Analyze made against this part file name.

Proximity report

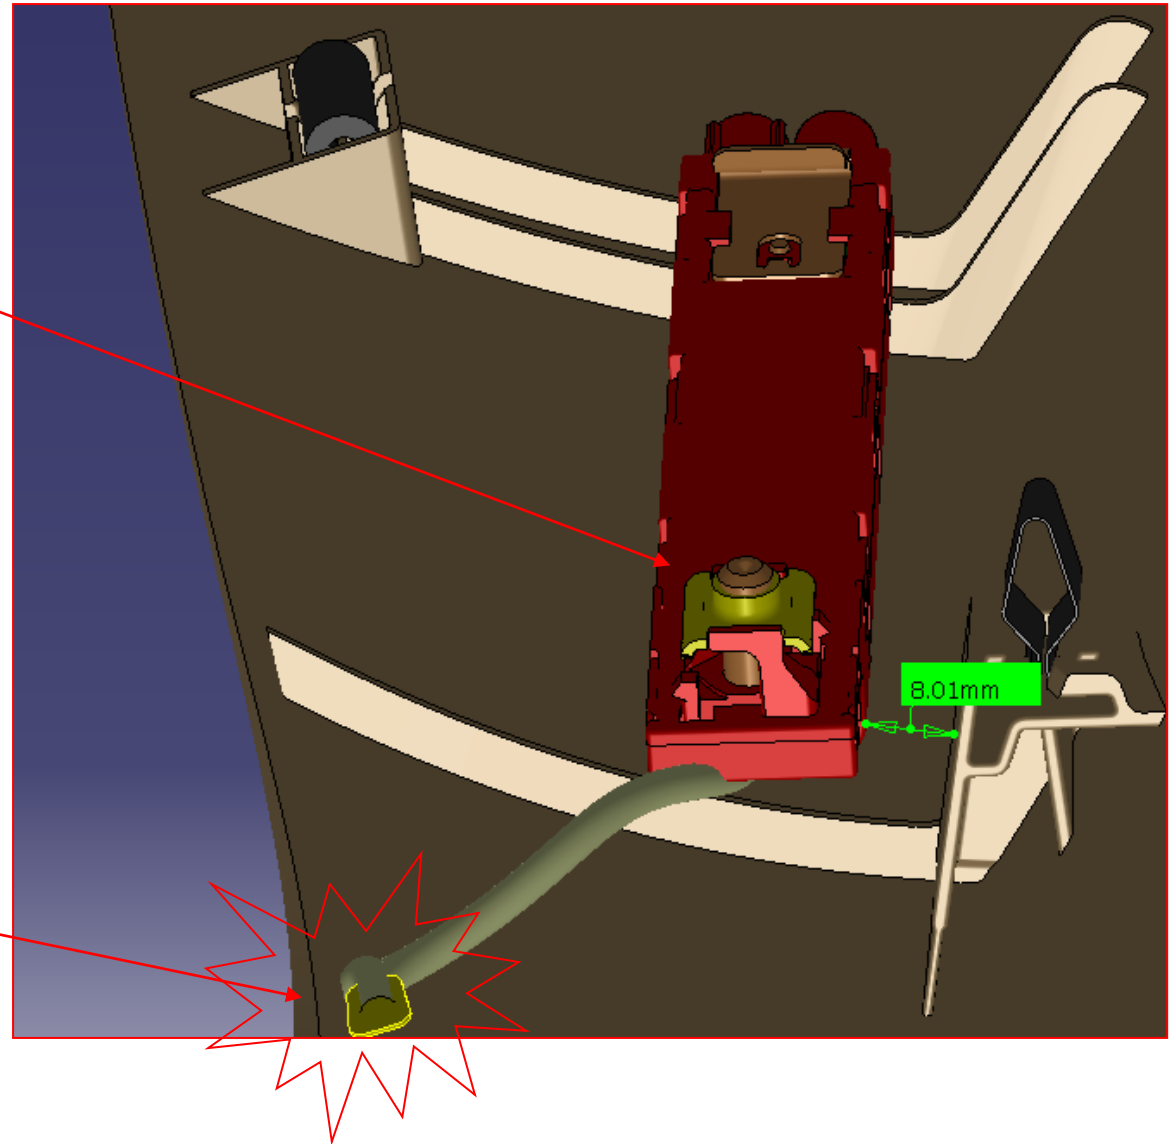
Minimum gap in X direction (real size) 8mm

Cable in clash

Notice: the cable was find in no show.

o.k.

I will inform Seat in case is important

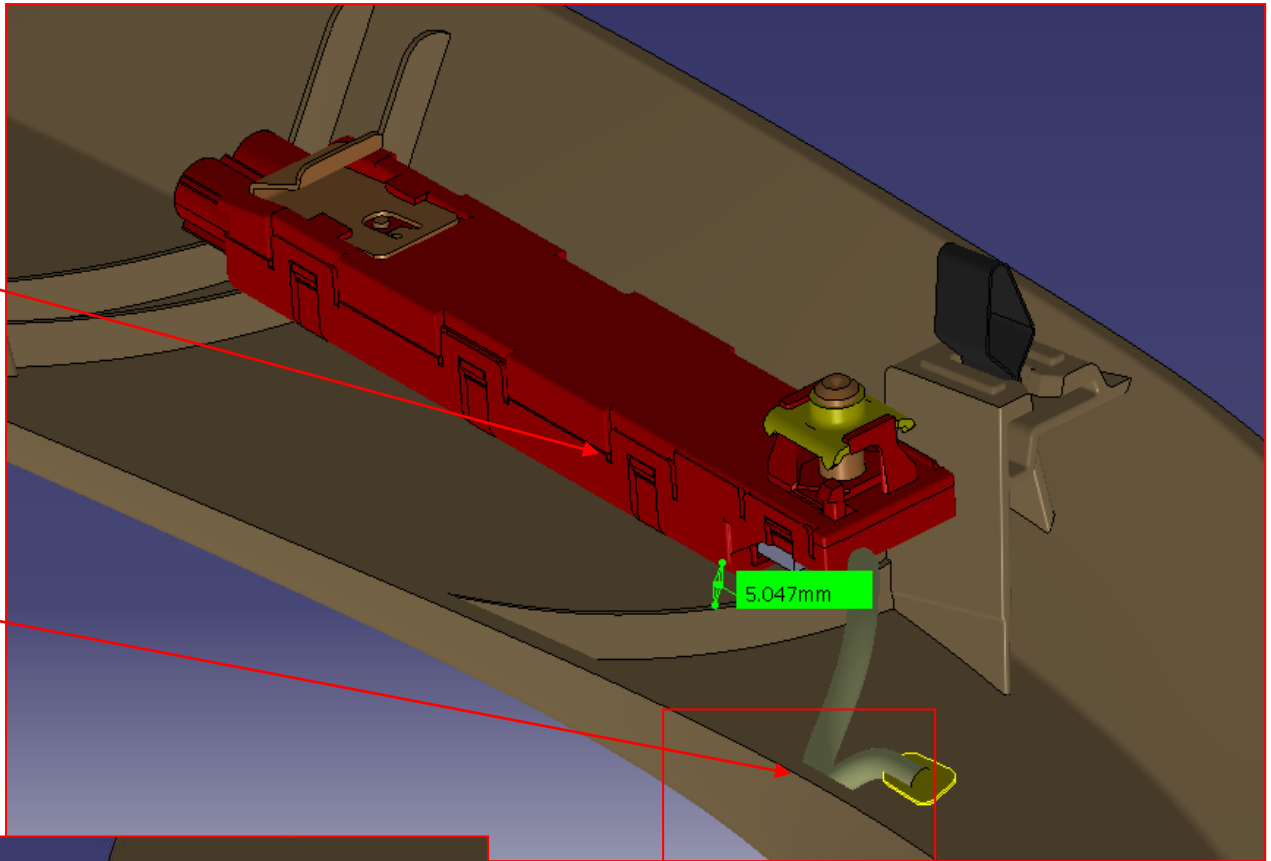
Clash max 0.21mm between upper part EOP and cable (EOP = end of part)

**SHOULD WE MAKE A CUTOUT IN ORDER TO AVOID THIS INTERFERENCE?
CLERANCE ?**

No

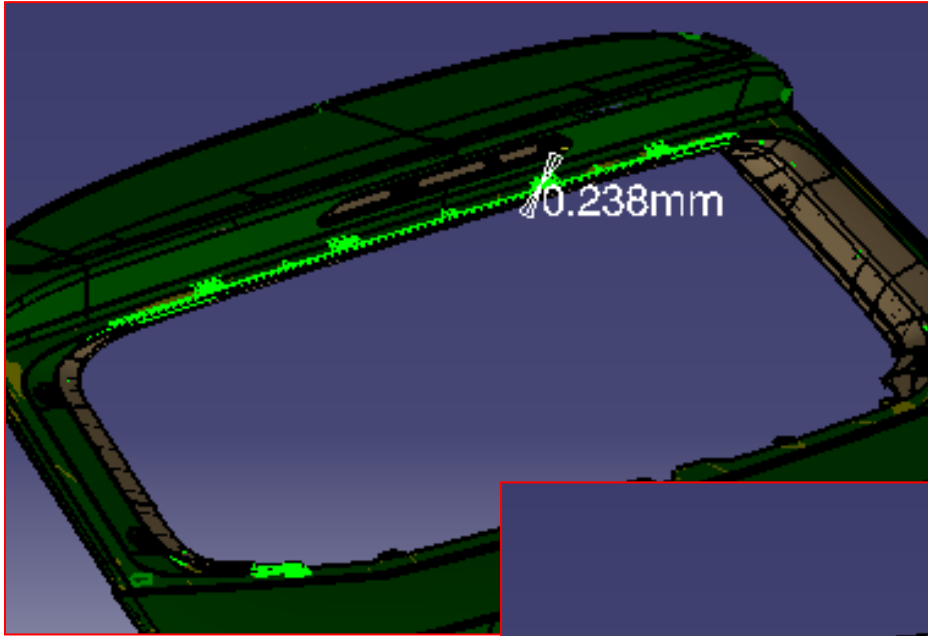
Minimum distance 0.24mm no clash

We should have clash as in this picture

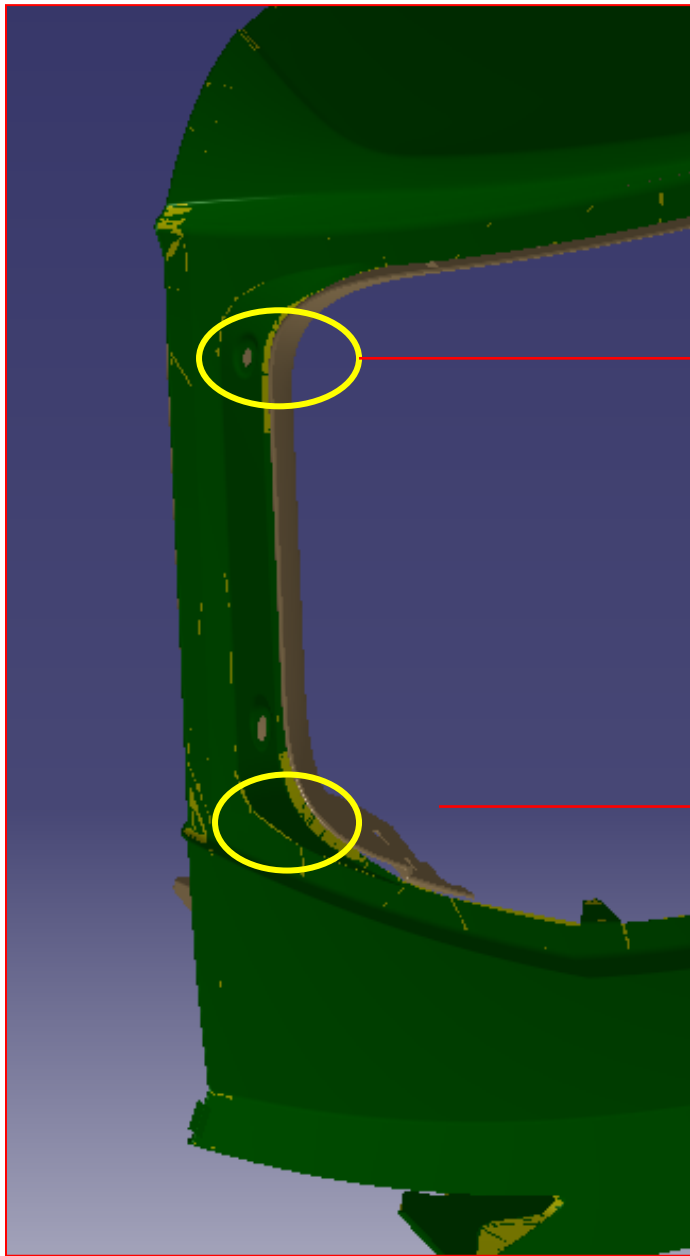
Clarence 0.5mm

PLEASE SPECIFY IF 0.413 IT COULD BE CONSIDERED CORRECT, OR, WE SHOULD PASS TO 0.5mm.

It is correct. This will be an adjustment area

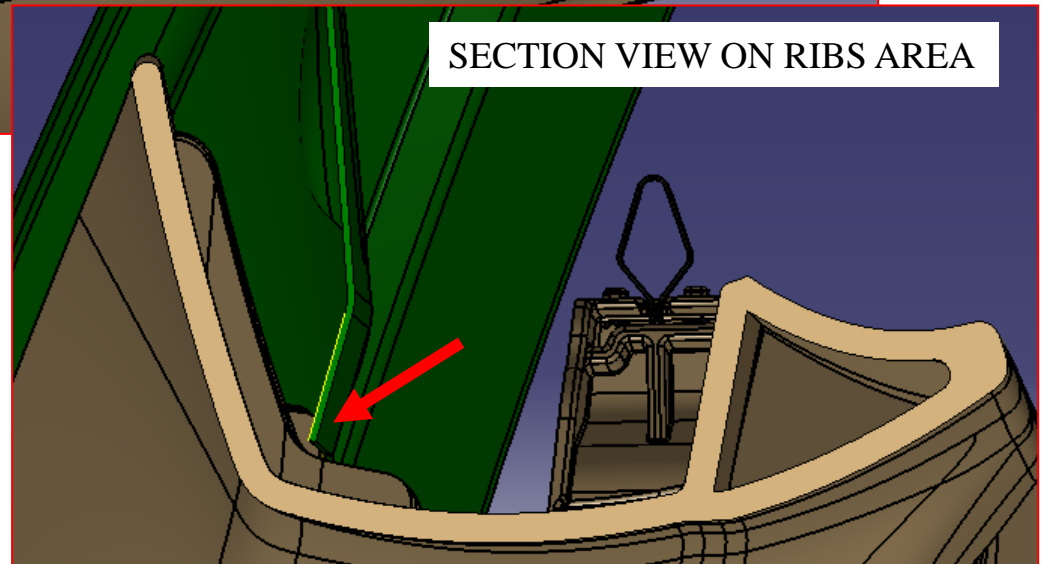
Side ribs proximity 1mm minimum.

PLEASE SPECIFY IF THE 1mm GAP IS GOOD ENOUGH (RIB HIGH 3mm).

PLEASE SPECIFY IF THE 1.5mm GAP IS GOOD ENOUGH.

Please, get a minimum gap of 1,5mm.

o.k.

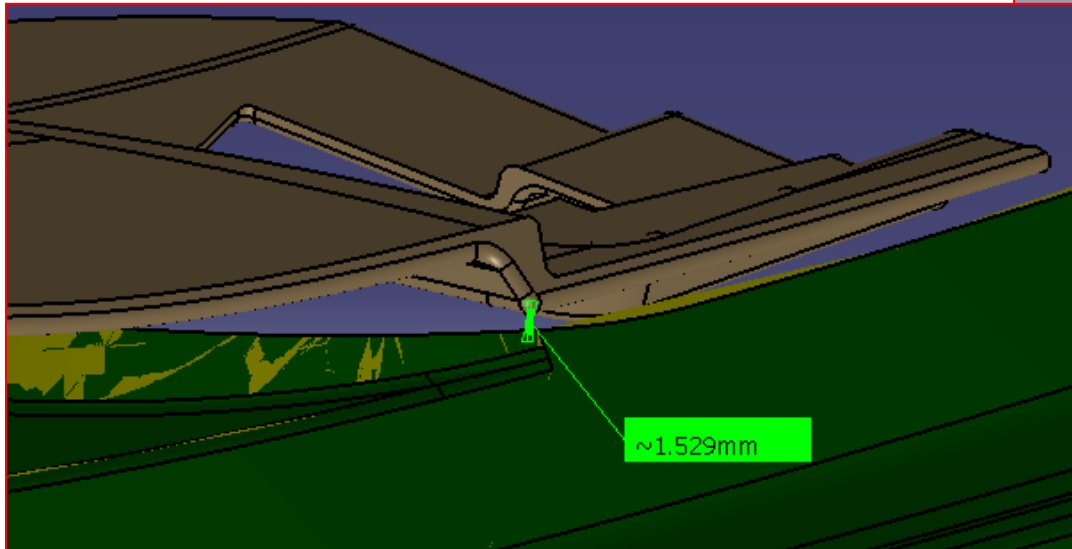
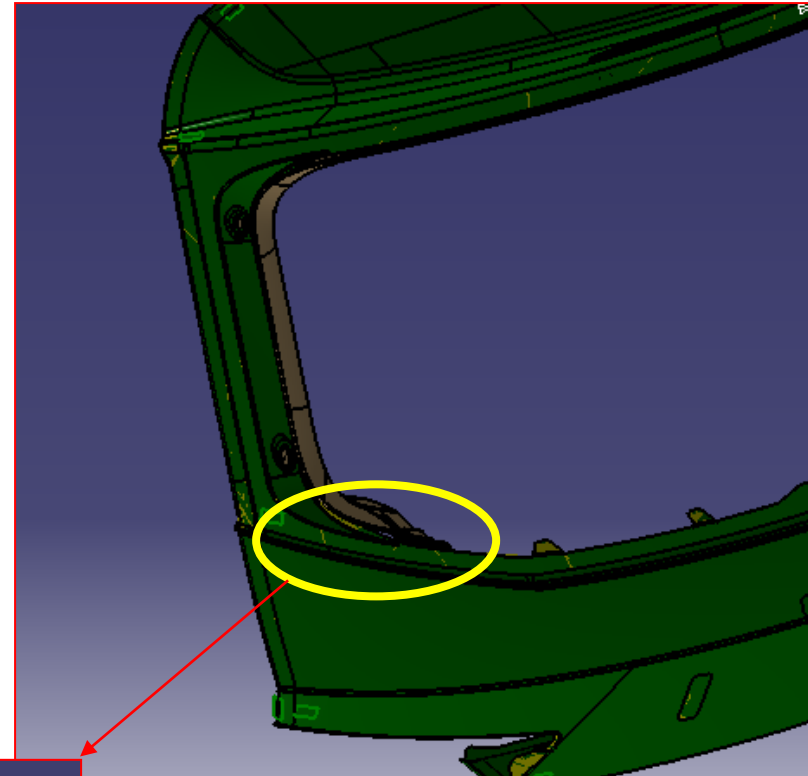
GAP 1.5 mm

**PLEASE SPECIFY IF THE
3 mm GAP IS GOOD
ENOUGH.**

o.k.

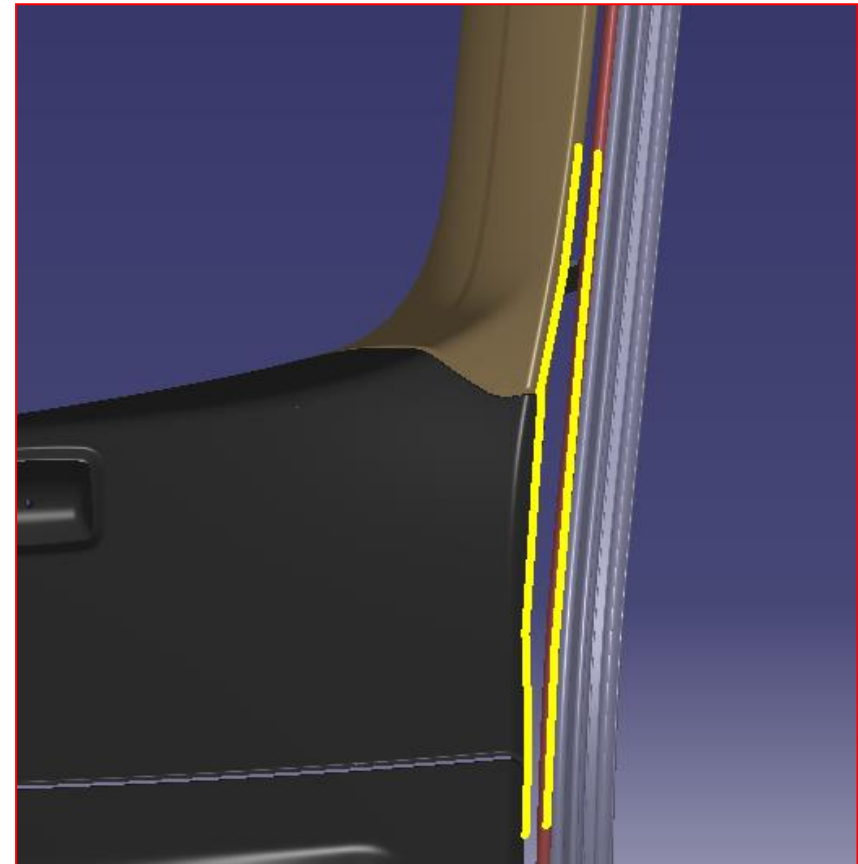
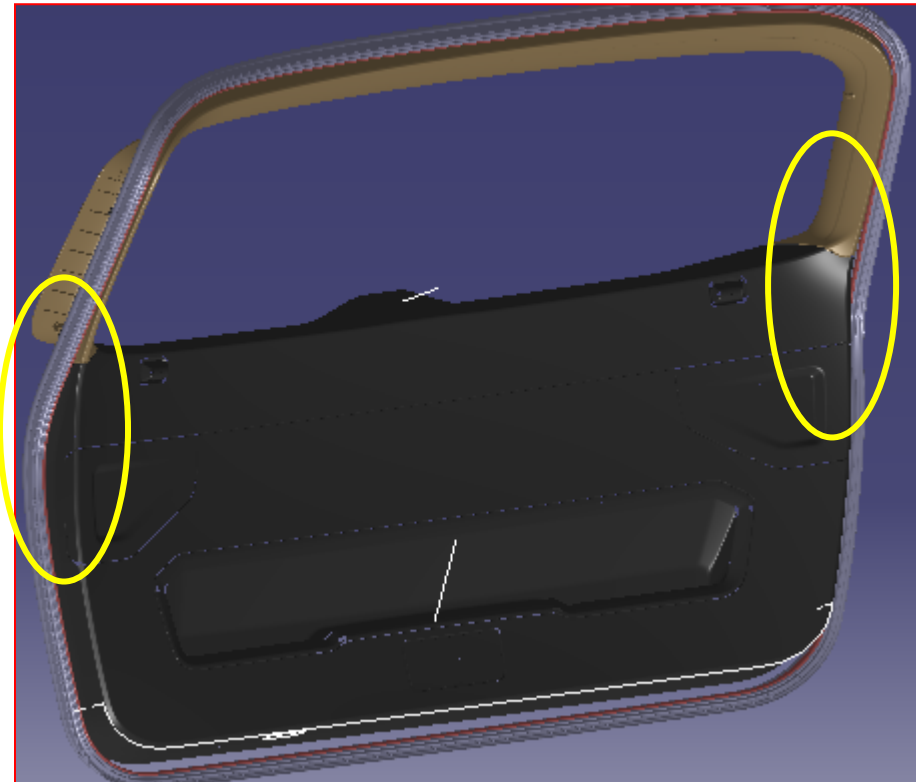
Appearance - not constant gap in this area

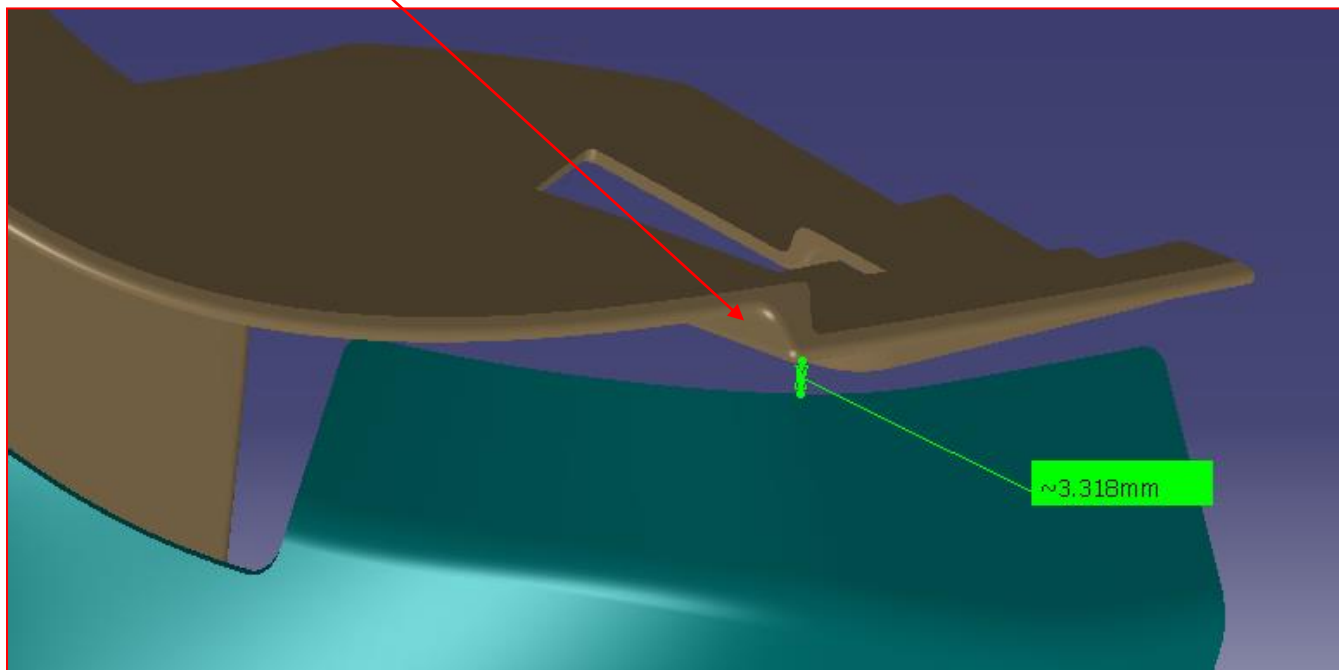
**PLEASE SPECIFY IF THE
3.3 mm GAP IS GOOD
ENOUGH.**

Gap 3.3mm in Z direction.

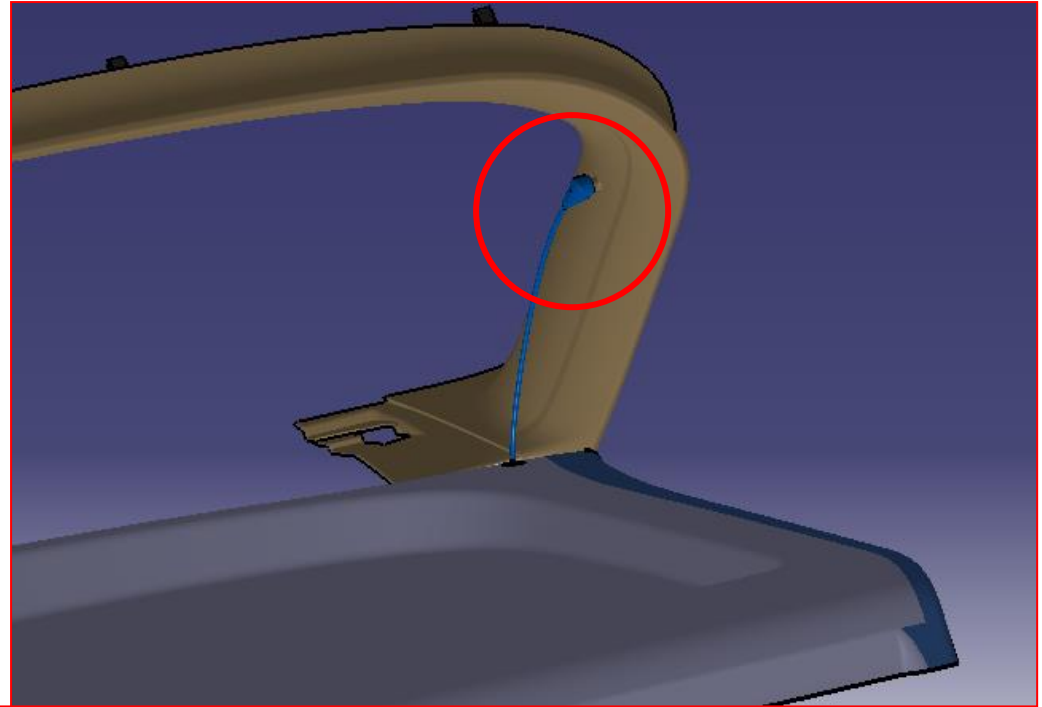
Environment in wrong position

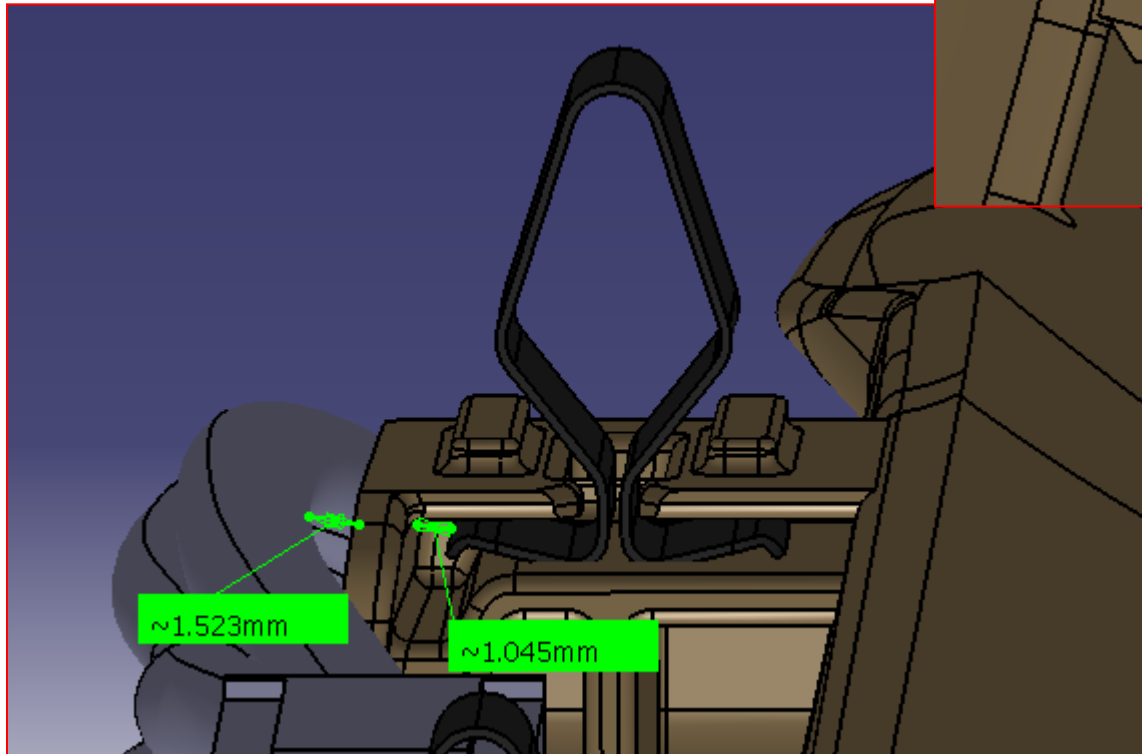
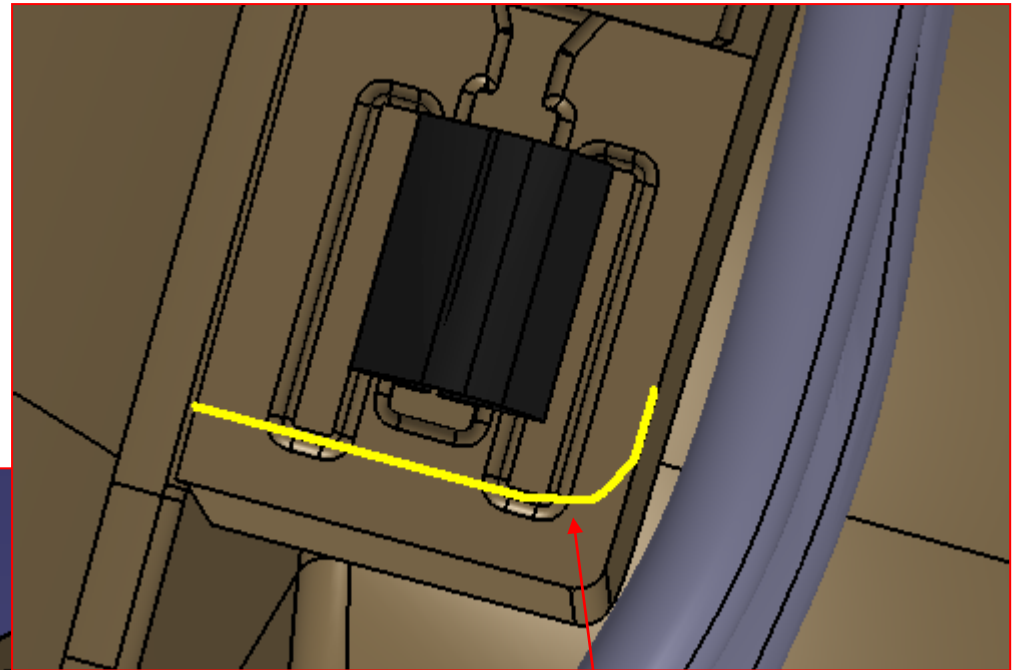
Should we try to reach the yellow limit?

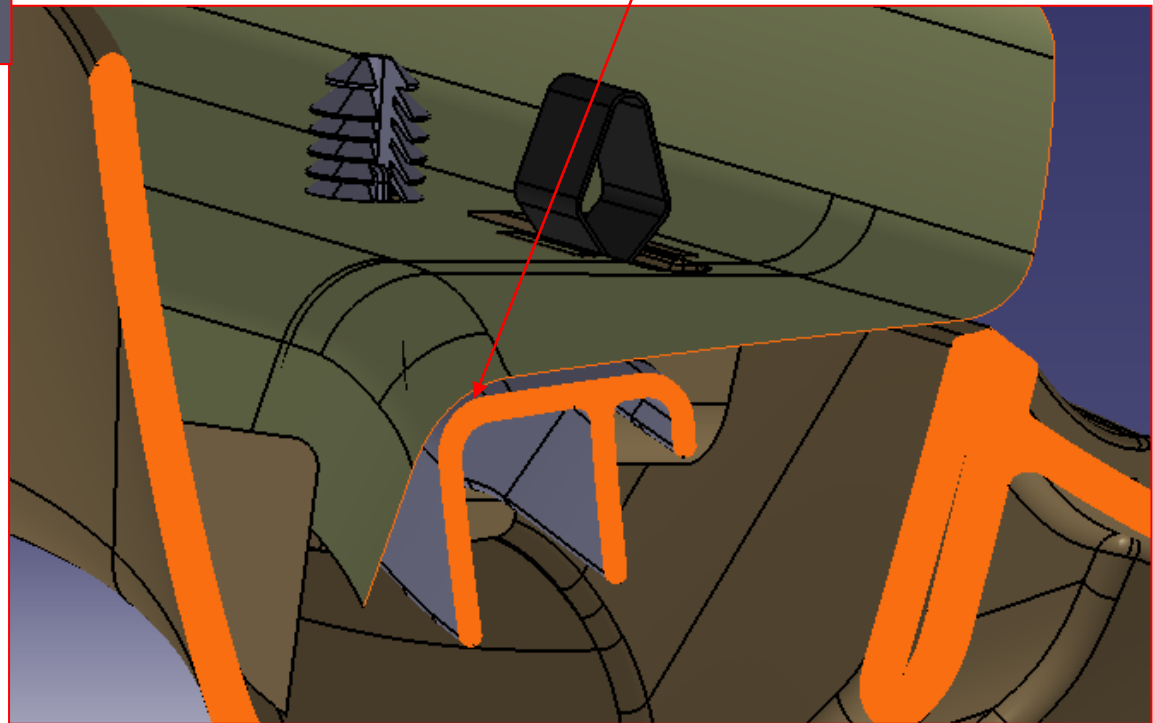
??? - do we have the last INNENTEIL?
Contact gulotte - BIW
